**Evanswood Infrastructure Improvements  
Maple Grove, MN  
Lumen Facilities  
Reviewed by RJ Allison on 06/29/2022**

Below are the following Lumen conflicts as part of the Evanswood Infrastructure Improvements Project in Maple Grove, MN.

**LUMEN WORK PLAN**  
**PROJECT N.974575 / TERR-1006777**

SURVEY: TNA  
DRAWN: ASB/JLT  
DESIGNED: ASB/JLT  
CHECKED: TJM  
APPROVED: TJM  
PROJ. NO.: 193805231  
SHEET NUMBER: **C4.01**

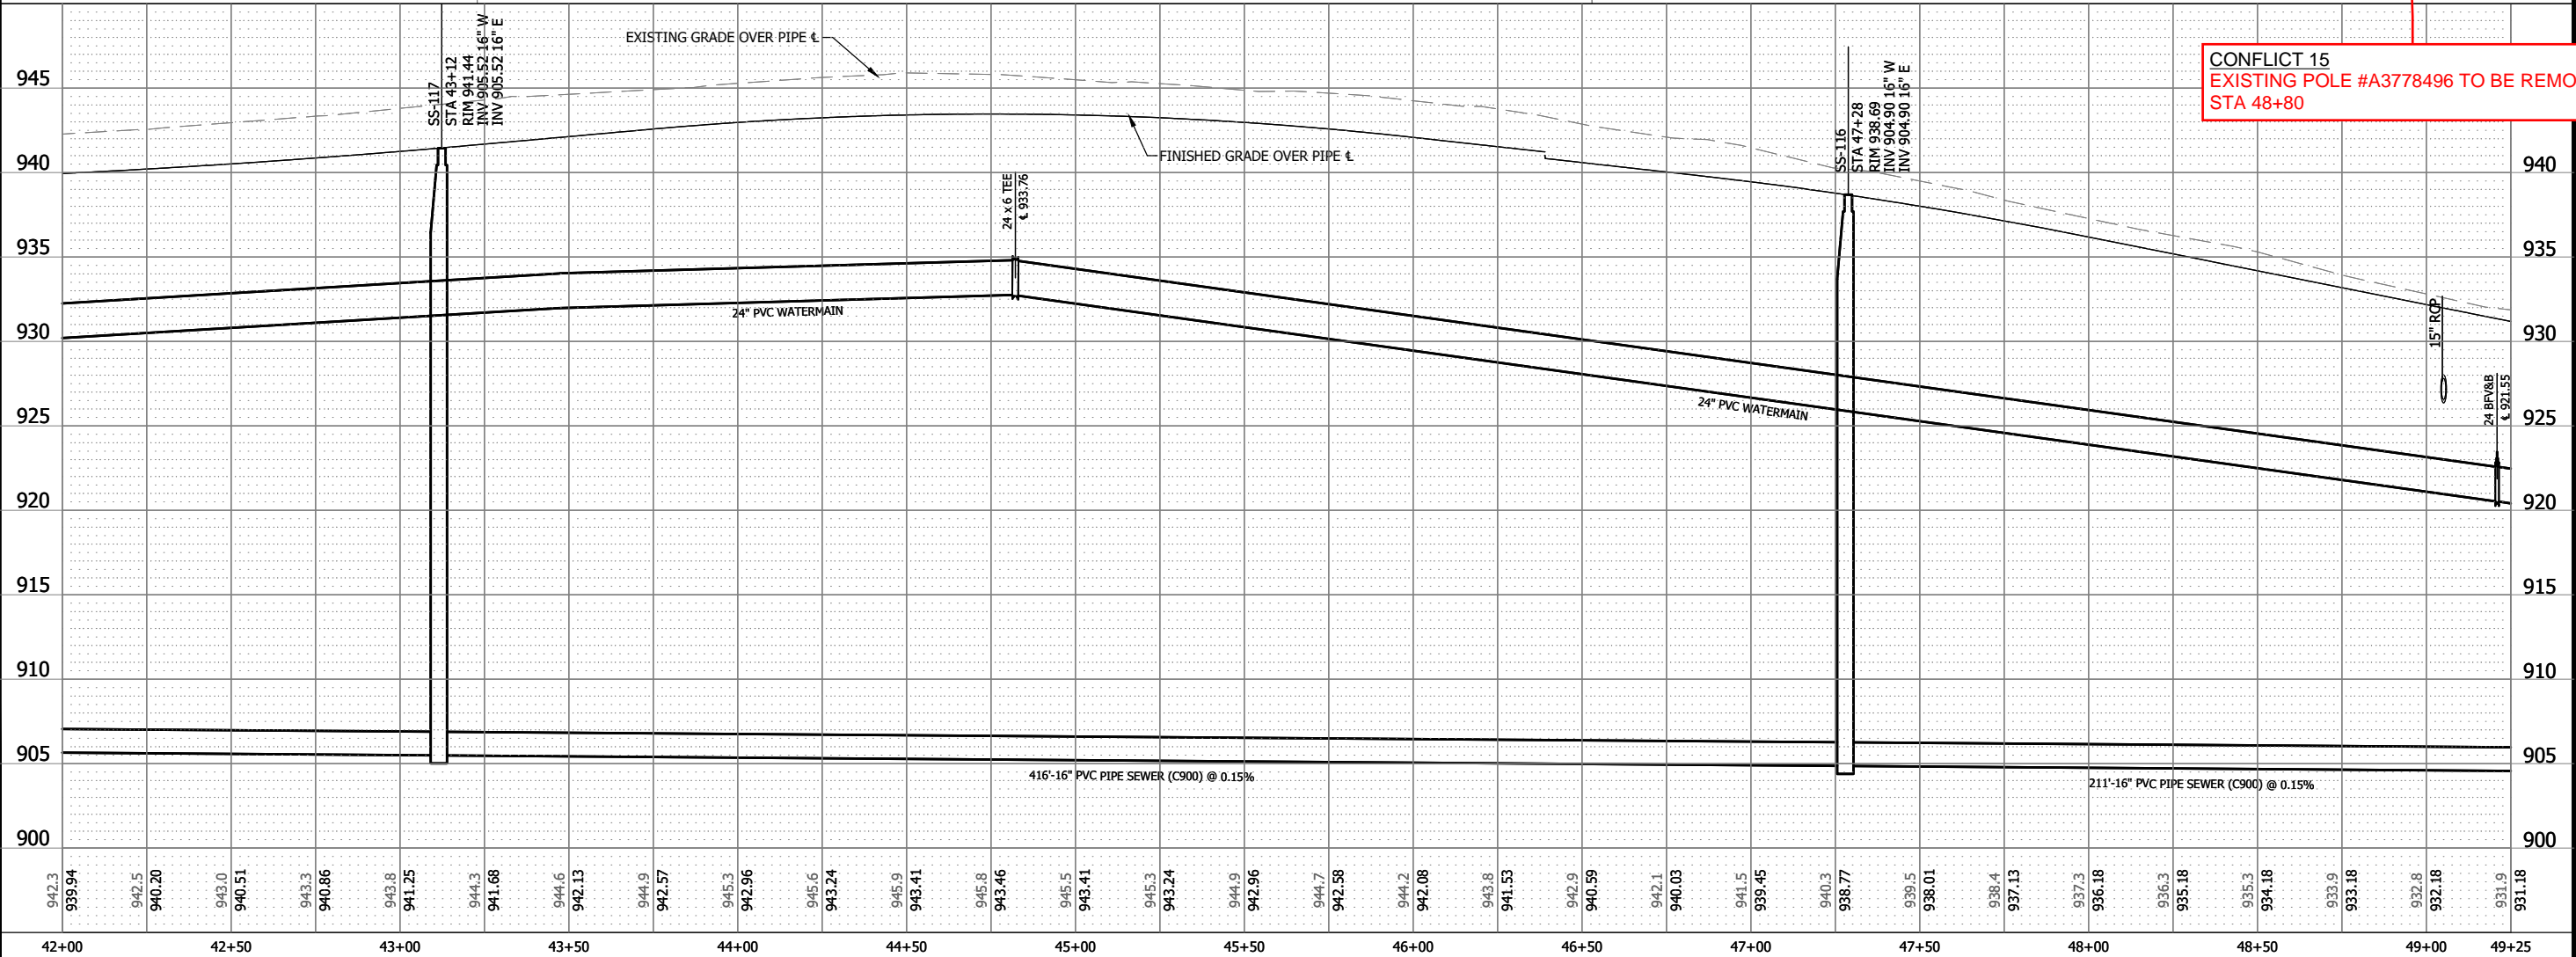
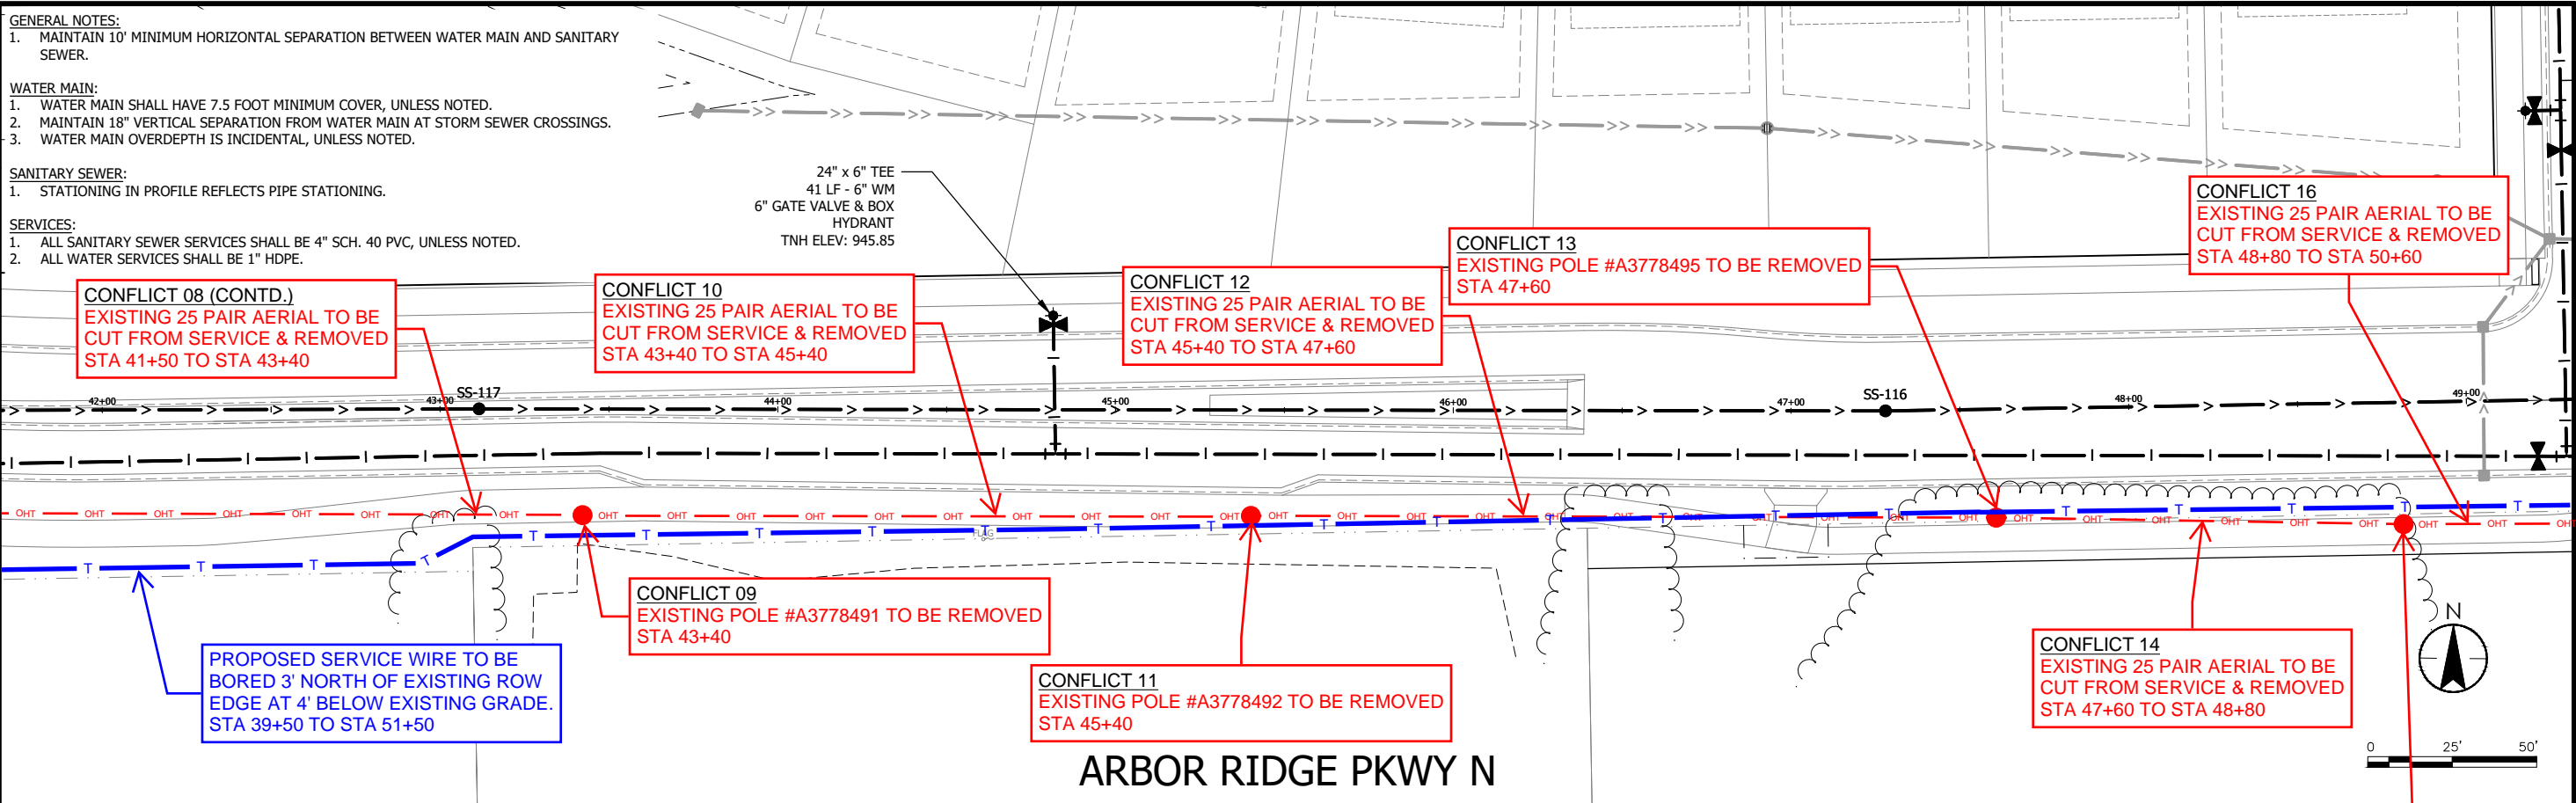
01. Arbor Ridge Pkwy (101<sup>st</sup> Ave N), STA 35+75 to STA 37+50 (RT), Sheet C4.01  
Conflict: Existing 25 pair aerial attached to Lumen poles scheduled for removal.  
Solution: Lumen to cut aerial cable from service & remove. Lumen to bore new 25 pair according to callouts and linework on work plan.

02. Arbor Ridge Pkwy (101<sup>st</sup> Ave N), STA 37+50 (RT), Sheet C4.01  
Conflict: Existing pole in conflict with proposed grading and future trail construction.  
Solution: Lumen to remove pole.

03. Arbor Ridge Pkwy (101<sup>st</sup> Ave N), STA 37+50 (LT to RT), Sheet C4.01  
Conflict: Existing 25 pair in conflict with proposed storm sewer.  
Solution: Lumen to cut cable from service and remove. Lumen to bore new 25 pair across the road at 5' below existing grade and continue bore for approximately 60' along existing ROW edge to splice into existing 25 pair.

04. Arbor Ridge Pkwy (101<sup>st</sup> Ave N), STA 37+50 to STA 39+60 (RT), Sheet C4.01  
Conflict: Existing 25 pair aerial attached to Lumen poles scheduled for removal.  
Solution: Lumen to cut aerial cable from service & remove. Lumen to bore new service according to callouts and linework on work plan.

05. Arbor Ridge Pkwy (101<sup>st</sup> Ave N), STA 39+60 (RT), Sheet C4.01  
Conflict: Existing pole in conflict with proposed grading and future trail construction.  
Solution: Lumen to remove pole.

06. Arbor Ridge Pkwy (101<sup>st</sup> Ave N), STA 39+60 to STA 41+50 (RT), Sheet C4.01  
Conflict: Existing 25 pair aerial attached to Lumen poles scheduled for removal.  
Solution: Lumen to cut aerial cable from service & remove. Lumen to bore new service according to callouts and linework on work plan.

07. Arbor Ridge Pkwy (101<sup>st</sup> Ave N), STA 41+50 (RT), Sheet C4.01  
Conflict: Existing pole in conflict with proposed grading and future trail construction.  
Solution: Lumen to remove pole.

08. Arbor Ridge Pkwy (101<sup>st</sup> Ave N), STA 41+50 to STA 43+40 (RT), Sheet C4.01 to C4.02  
Conflict: Existing 25 pair aerial attached to Lumen poles scheduled for removal.  
Solution: Lumen to cut aerial cable from service & remove. Lumen to bore new service according to callouts and linework on work plan.

**CONFLICT 08 (CONTD.)**

EXISTING 25 PAIR AERIAL TO BE CUT FROM SERVICE & REMOVED STA 41+50 TO STA 43+40

PROPOSED SERVICE WIRE TO BE BORED 3' NORTH OF EXISTING ROW EDGE AT 4" BELOW EXISTING GRADE. STA 39+50 TO STA 51+50

SURVEY: TNA  
DRAWN: ASB/JLT  
DESIGNED: ASB/JLT  
CHECKED: TJM  
APPROVED: TJM  
PROJ. NO.: 193805231  
SHEET NUMBER: C4.02

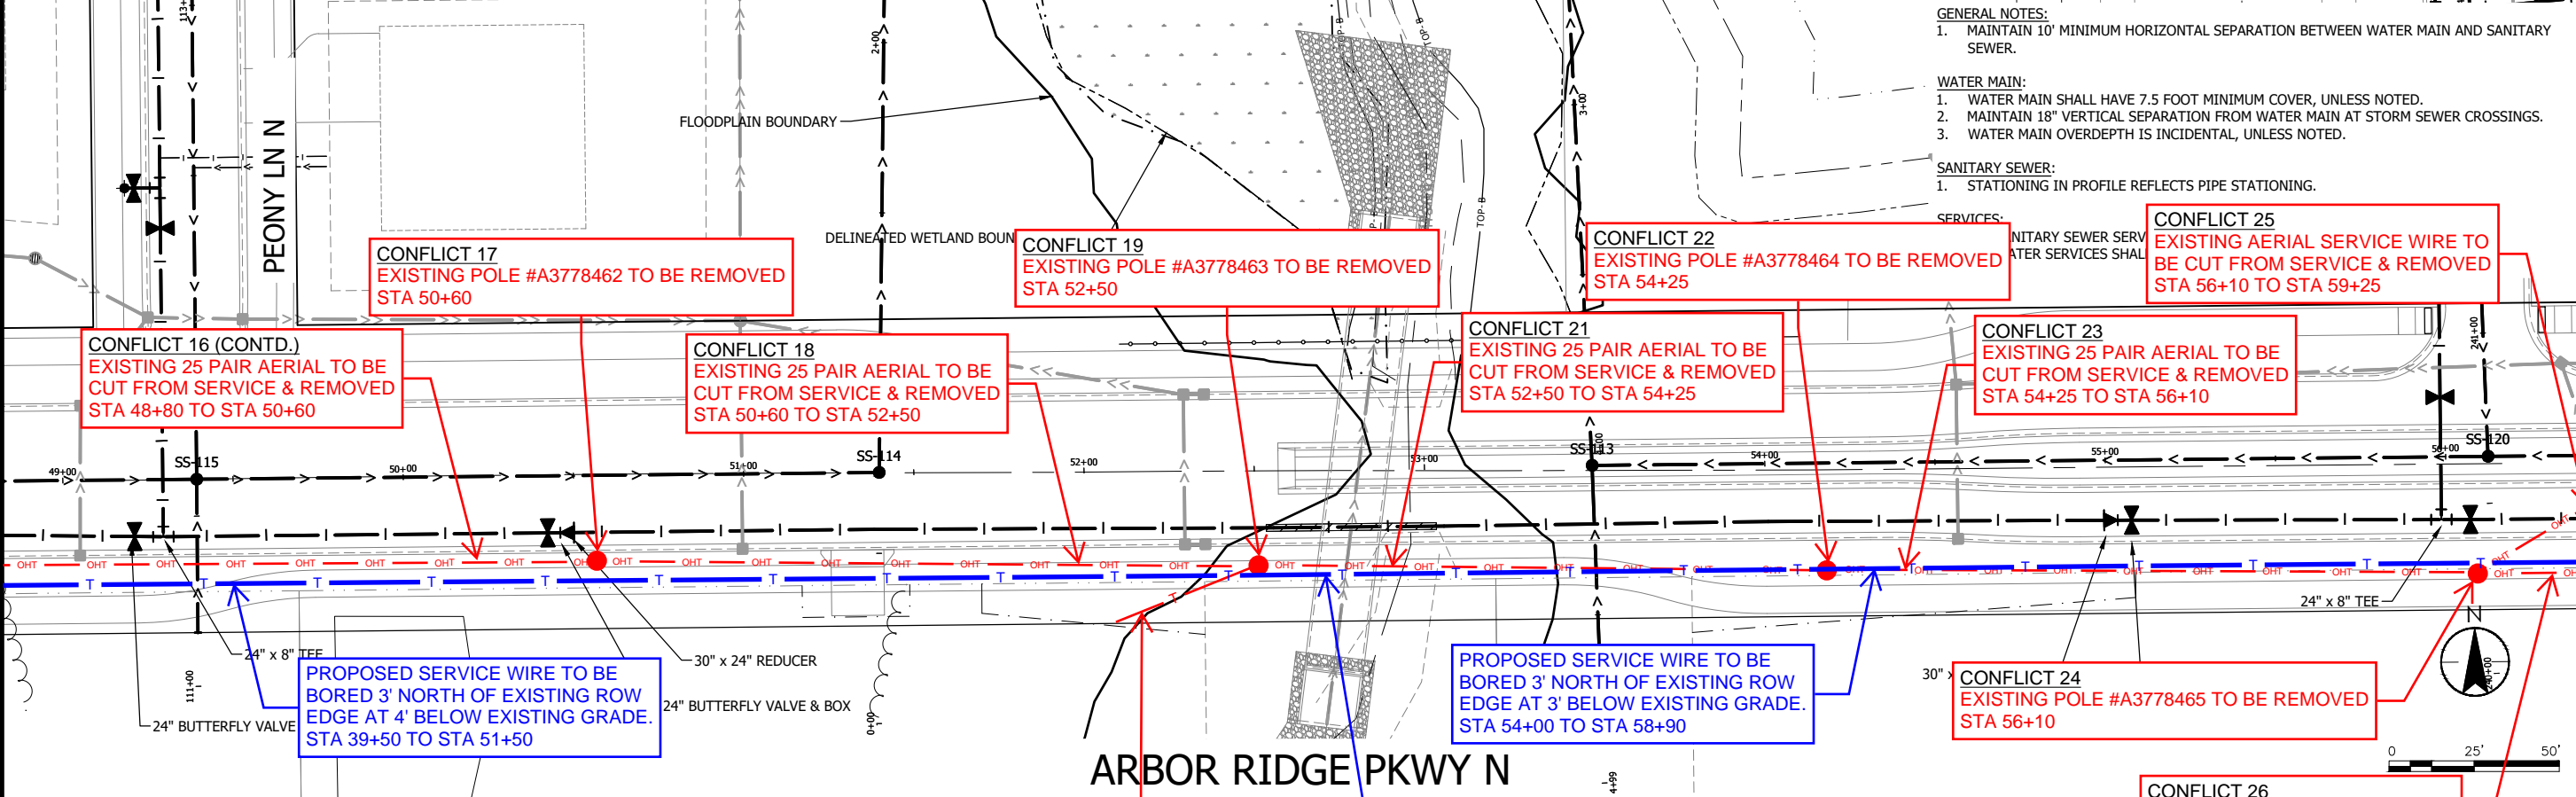
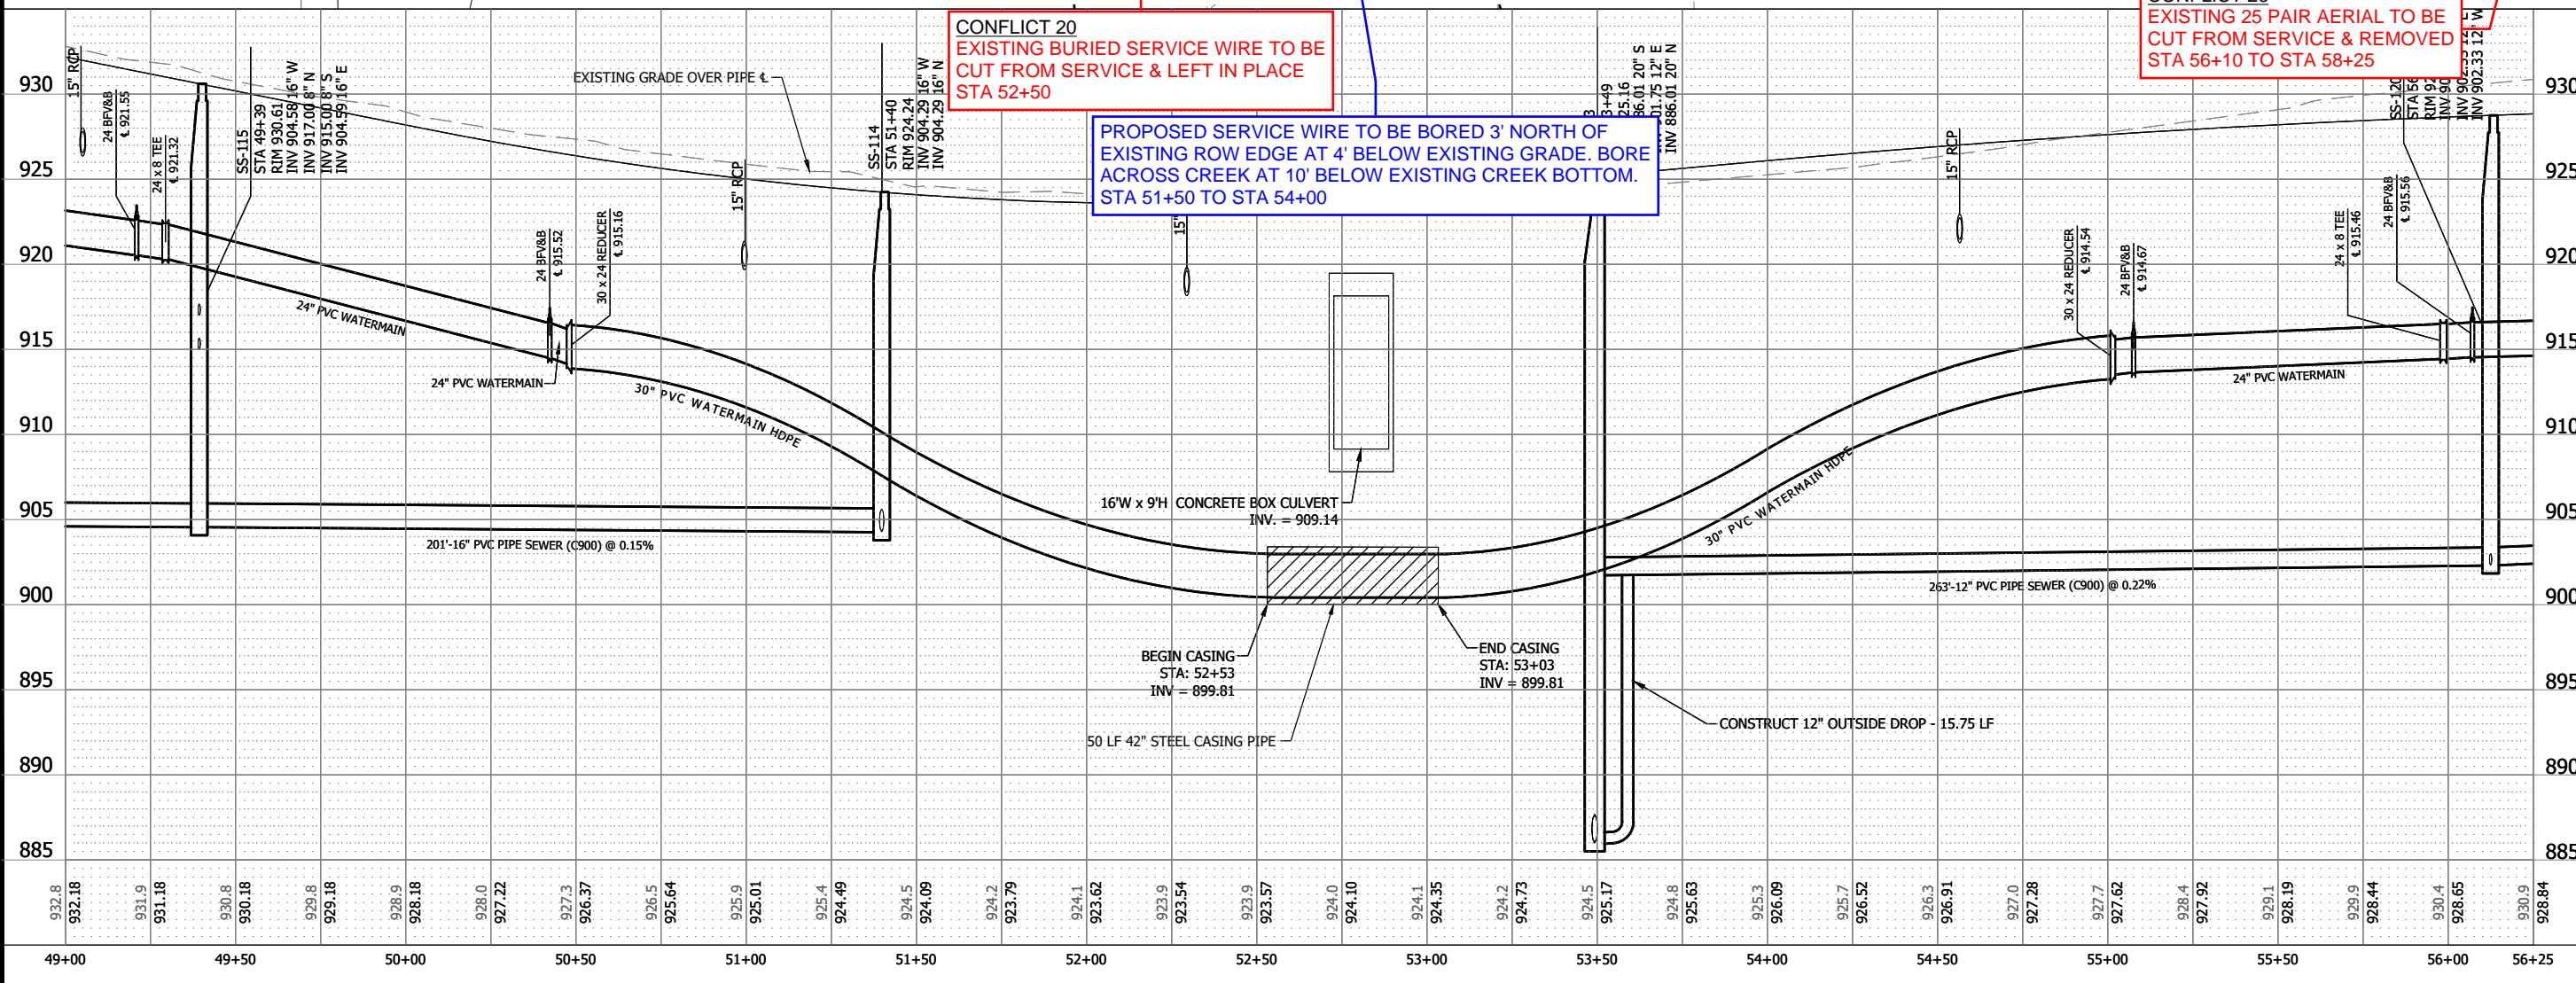
09. Arbor Ridge Pkwy (101<sup>st</sup> Ave N), STA 43+40 (RT), Sheet C4.02  
Conflict: Existing pole in conflict with proposed grading and future trail construction.  
Solution: Lumen to remove pole.

10. Arbor Ridge Pkwy (101<sup>st</sup> Ave N), STA 43+40 to STA 45+40 (RT), Sheet C4.02  
Conflict: Existing 25 pair aerial attached to Lumen poles scheduled for removal.  
Solution: Lumen to cut aerial cable from service & remove. Lumen to bore new service according to callouts and linework on work plan.

11. Arbor Ridge Pkwy (101<sup>st</sup> Ave N), STA 45+40 (RT), Sheet C4.02  
Conflict: Existing pole in conflict with proposed grading and future trail construction.  
Solution: Lumen to remove pole.

12. Arbor Ridge Pkwy (101<sup>st</sup> Ave N), STA 45+40 to STA 47+60 (RT), Sheet C4.02  
Conflict: Existing 25 pair aerial attached to Lumen poles scheduled for removal.  
Solution: Lumen to cut aerial cable from service & remove. Lumen to bore new service according to callouts and linework on work plan.

13. Arbor Ridge Pkwy (101<sup>st</sup> Ave N), STA 47+60 (RT), Sheet C4.02  
Conflict: Existing pole in conflict with proposed grading and future trail construction.  
Solution: Lumen to remove pole and buried service wire drop.

14. Arbor Ridge Pkwy (101<sup>st</sup> Ave N), STA 47+60 to STA 48+80 (RT), Sheet C4.02  
Conflict: Existing 25 pair aerial attached to Lumen poles scheduled for removal.  
Solution: Lumen to cut aerial cable from service & remove. Lumen to bore new service according to callouts and linework on work plan.

15. Arbor Ridge Pkwy (101<sup>st</sup> Ave N), STA 48+80 (RT), Sheet C4.02  
Conflict: Existing pole in conflict with proposed grading and future trail construction.  
Solution: Lumen to remove pole.

16. Arbor Ridge Pkwy (101<sup>st</sup> Ave N), STA 48+80 to STA 50+60 (RT), Sheet C4.02 to C4.03  
Conflict: Existing 25 pair aerial attached to Lumen poles scheduled for removal.  
Solution: Lumen to cut aerial cable from service & remove. Lumen to bore new service according to callouts and linework on work plan.

**CONFLICT 10**

EXISTING 25 PAIR AERIAL TO BE CUT FROM SERVICE & REMOVED STA 43+40 TO STA 45+40

**CONFLICT 12**

EXISTING 25 PAIR AERIAL TO BE CUT FROM SERVICE & REMOVED STA 45+40 TO STA 47+60

**CONFLICT 13**

EXISTING POLE #A3778495 TO BE REMOVED STA 47+60

**CONFLICT 16**

EXISTING 25 PAIR AERIAL TO BE CUT FROM SERVICE & REMOVED STA 48+80 TO STA 50+60

**CONFLICT 09**

EXISTING POLE #A3778491 TO BE REMOVED STA 43+40

**CONFLICT 11**

EXISTING POLE #A3778492 TO BE REMOVED STA 45+40

**CONFLICT 14**

EXISTING 25 PAIR AERIAL TO BE CUT FROM SERVICE & REMOVED STA 47+60 TO STA 48+80

**CONFLICT 15**

EXISTING POLE #A3778496 TO BE REMOVED STA 48+80
